# Proposal for the 03 Series of Amendments to the UN Regulation No. 134 (Hydrogen and Fuel Cell Vehicles)

# Submitted by the Task Force amending UN Regulation No. 134\*\*

# I. Proposal

Figure 2
Verification Test for Expected On-Road Performance (Pneumatic/hydraulie)

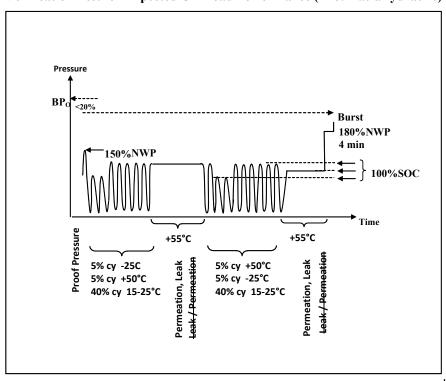
Figure 2., amend to read:

This proposal clarifies the order of the permeation and leak test in Figure 2 in alignment with the text and, in addition, streamlines the wording for headlines and text regarding these tests. There is no change to the technical requirements.
